Development Review Board

Tuesday, September 17, 2024, 5:00 PM

TO: Development Review Board
FROM: Scott Gustin
DATE: September 17, 2024
RE: ZP-24-335; 149 Beaumont Avenue

Request: Proposed amendment to ZP-19-590 for the fulfillment of Condition #1 in response to approved 2023-2028 JIPMP and TDM practices.

Level 10 as expanded, with balconies illustrated.

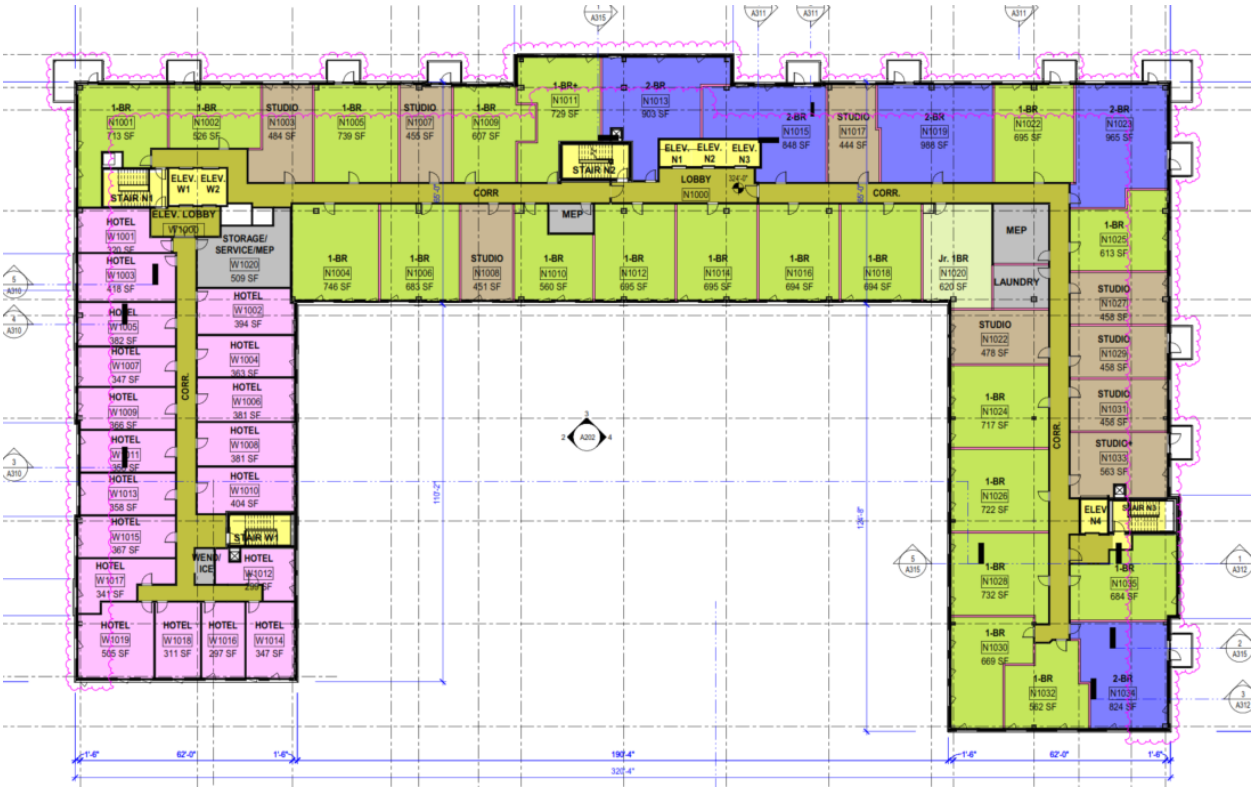
The overall roof height will remain less than the original 2021 approval and below than the 160' maximum allowable. **Affirmative finding.**

Level 9 (now Level 10) as approved under ZP-23-164

Section 14.6.4 Building Height
(f) Design and Public Space Standards Required for Additional Building Height
i. Design Standards: The maximum building height and mass is permitted By Right by the underlying Form District, as may be modified by the chosen Building Type and Frontage Type.
